NEW MEXICO OIL CONSERVATION DIVISION
- Geological & Engineering Bureau –
1220 South St. Francis Drive, Santa Fe, NM 87505

RE: C-108, SWD APPLICATION
FEDERAL T SWD #1– API#: 30-015-26404
Unit Letter "A" Section 12 T18S R27E
Eddy County, New Mexico

APPLICATION FOR AUTHORIZATION TO INJECT

From: Goetze, Phillip, EMNRD
Sent: Wednesday, July 5, 2017 10:51 AM
To: Mike Pippin (mike@pippinllc.com)
Cc: Jones, William V, EMNRD; McMillan, Michael, EMNRD; Lowe, Leonard, EMNRD
Subject: Response Provided by HollyFrontier to Limerock's IPI Application
Attachments: 2017-06-27 Lime Rock Pressure Application Protest with attachments.pdf

Figure 1:

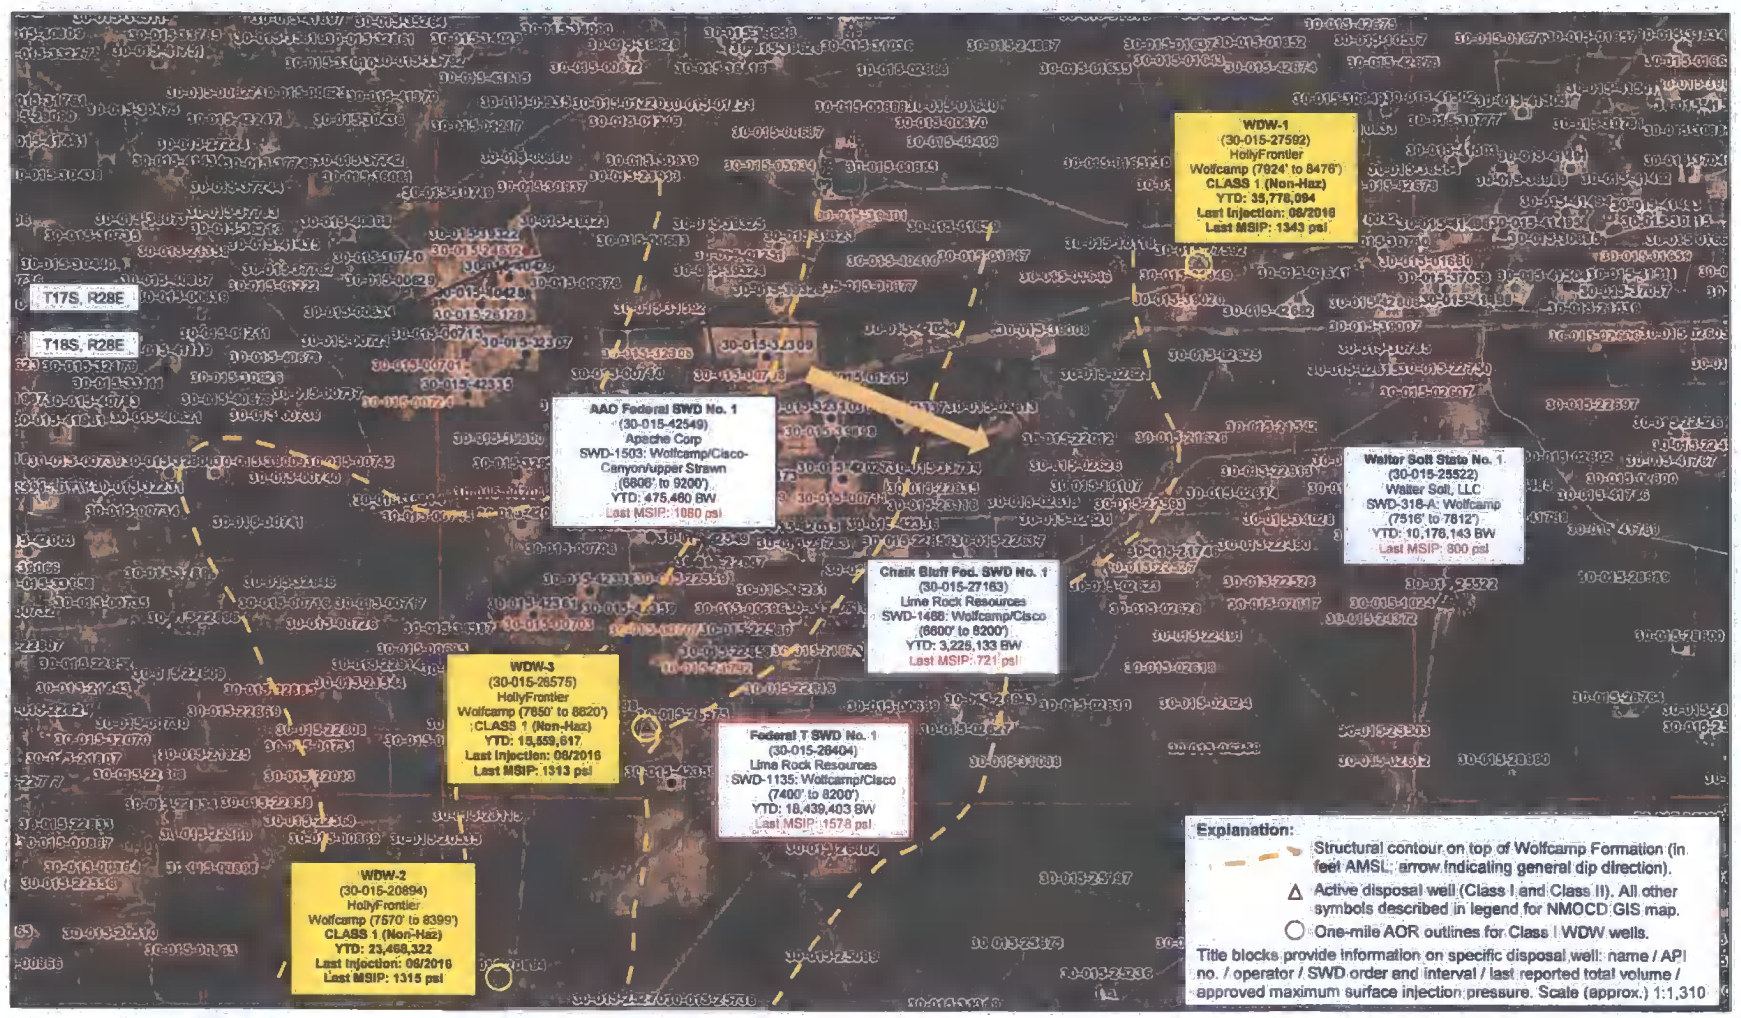
As seen in Figure 1, there are only approximately 2,500 feet separating HNFR's WDW-3 from Lime Rock's Federal T SWD #1, and both wells have completions in the same Cisco zone. The Federal T SWD #1 perforations in the Cisco Formation range from 7,685' to 8,060', and the WDW-3 Cisco perforations run from 7,666' to 8,620'. This overlap allows pressure fronts (and fluids) to migrate from the Lime Rock SWD to HNFR's WDW-3, potentially impairing the function of WDW-3.

Figure 2: Cross Section between WDW-3 and Federal T SWD #1

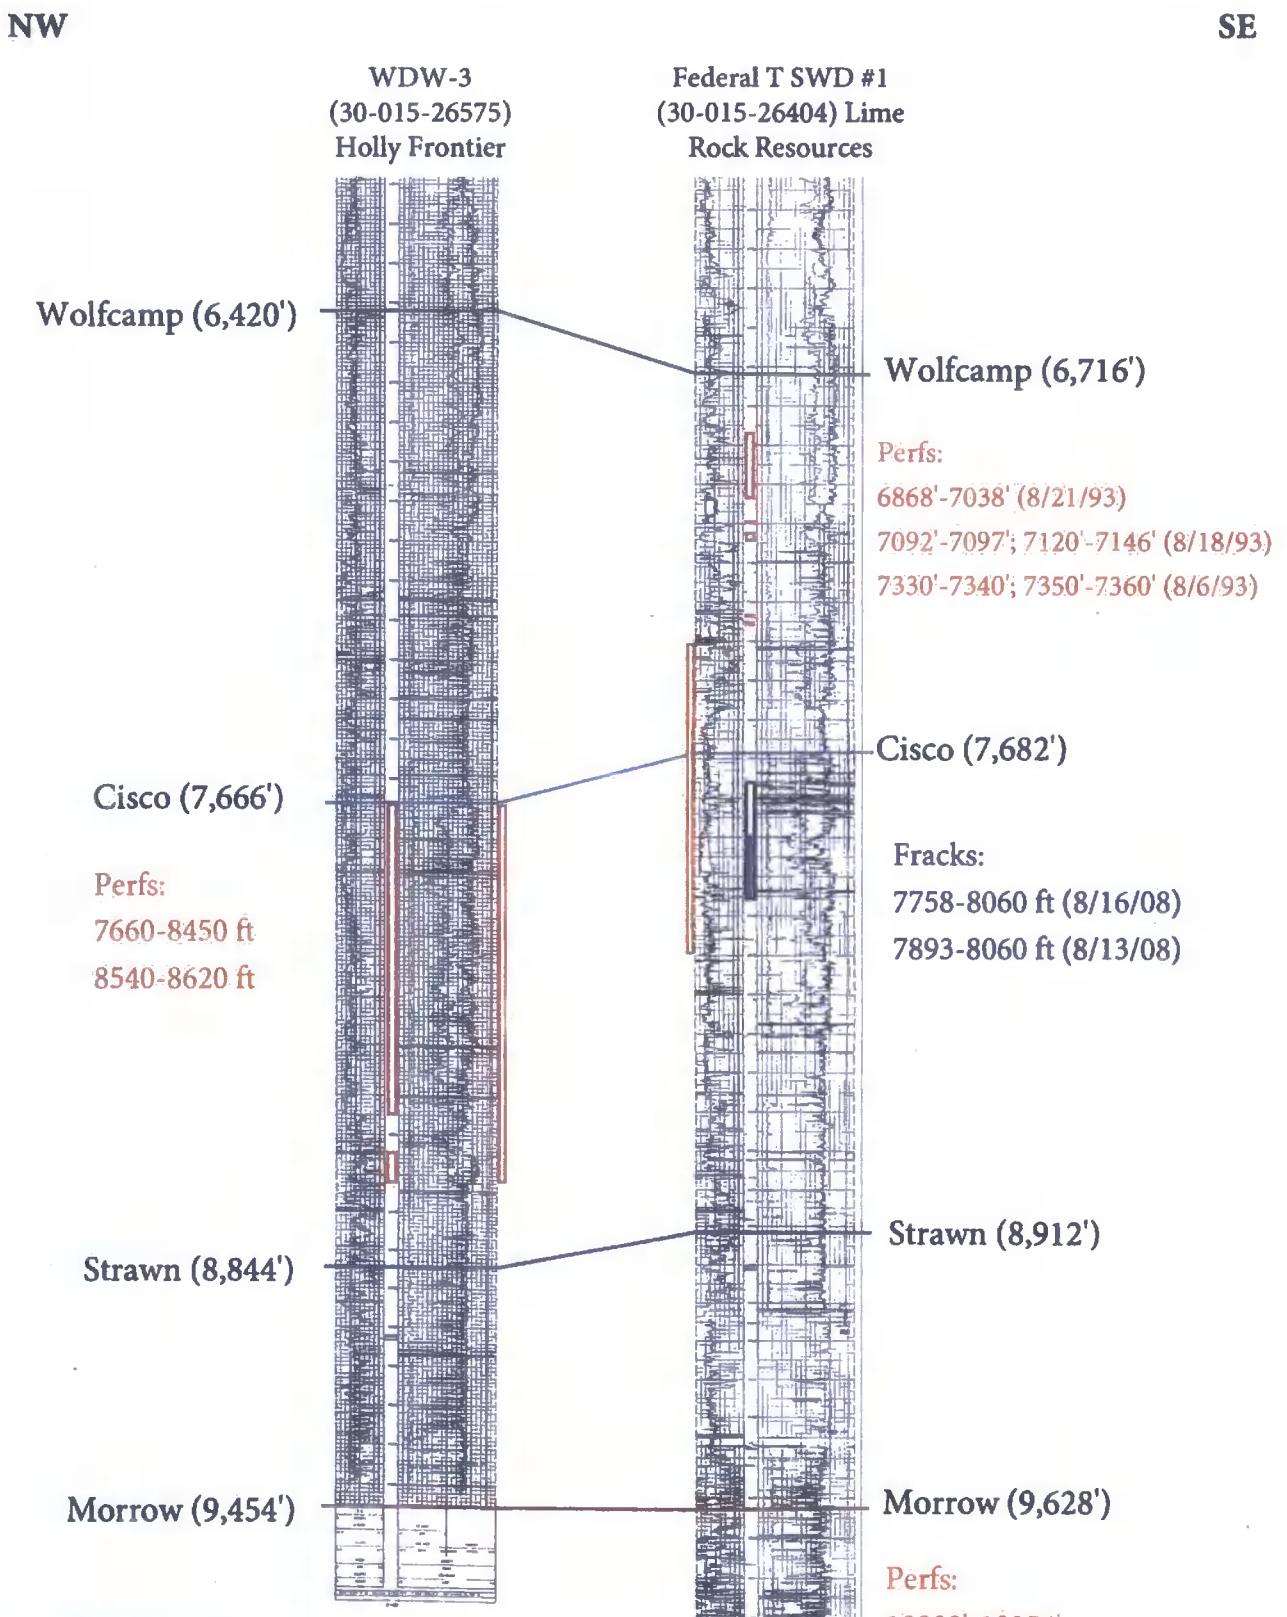
Figure 2 is a cross-section showing the geology of injection zones of WDW-3 and Federal T SWD#1. There is clearly an overlap of the injection zones in the Cisco Formation, the lithologies of the Cisco are very similar, and it is clear that there are no stratigraphic or structural barriers between the wells. This direct connection will ensure that increased injection pressure in the Federal T SWD #1 will result in the migration of a pressure wave to WDW-3 that will negatively affect HFNR's ability to stay within their approved MAOP of 1,550 psig surface.
